# ***Nomad***

# ALERT SERVICE BULLETIN

## **ELECTRICAL POWER – DC GENERATION GENERATOR CABLE INSPECTION AT FIREWALL AND FEED THROUGH STUD MODIFICATION (MOD N724)**

Record compliance with Alert Service Bulletin ANMD-24-5, Parts 1, 2 or 3 as appropriate in the airframe log book.

Figure 1 Generator Cables and Stud Assembly

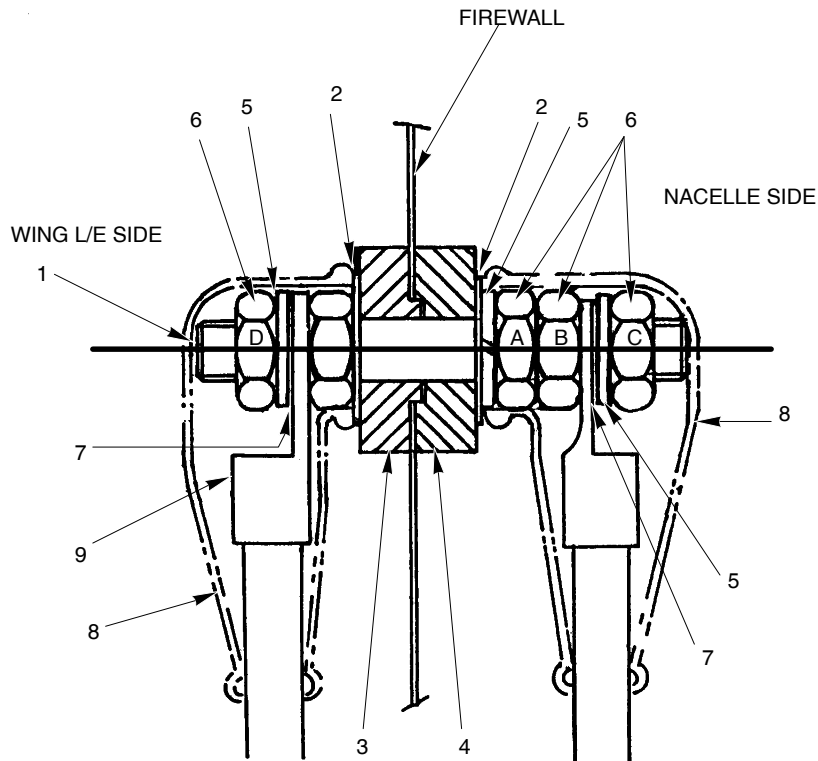
Mod N724 is introduced. This modification replaces existing Stud PN I/N-81-424 with a copper stud, PN I/N-81-925, using brass nuts. The increased electrical conductivity of the new assembly eliminates overheating problems, giving increased life to the generator cable connections in this area.

- (4) Re assemble the replacement stud PN I/N-81-925, observing the following sequence:-  
(all item numbers refer to Fig.1.)
  - (a) Assemble Special Washer, item 2, and Insulating Washer, item 3, on to the longer end of the new copper stud, item 1.

- (b) Insert the stud through the firewall, from the wing leading edge side, and add Insulating Washer, item 4, and Special Washer, item 2, followed by Spring Washer, item 5, and Nut, item 6A. Before running Nut, item 6A, fully home, apply Loctite 242 Nutlock to the threads on the copper stud, then tighten the nut to 20 inch pounds. Preparation, application and curing of the Loctite should be in accordance with the manufacturers instructions.
- (c) Assemble Locknut, item 6B, and tighten against item 6A to a Torque of 80 inch pounds.

- (d) Assemble the cable terminal lug, followed by Washer item 7, Spring Washer item 5, and Nut item 6C, and Torque tighten to 60 inch pounds, against Locknut item 6B. Replace the protective cover, item 8.
- (e) At the other end of the stud, on the wing leading edge side of the firewall, assemble the cable terminal lug, followed by Washer item 7, Spring Washer item 5, and Nut item 6D; torque tighten to 60 inch pounds against the stud hexagon. Replace the protective cover, item 8.
- (f) Remove the warning placard applied in accordance with PART 2.
- (g) Reconnect the battery and at the next engine start check Generator operation as per the "After Start" checks in Section 3 of the Flight Manual.
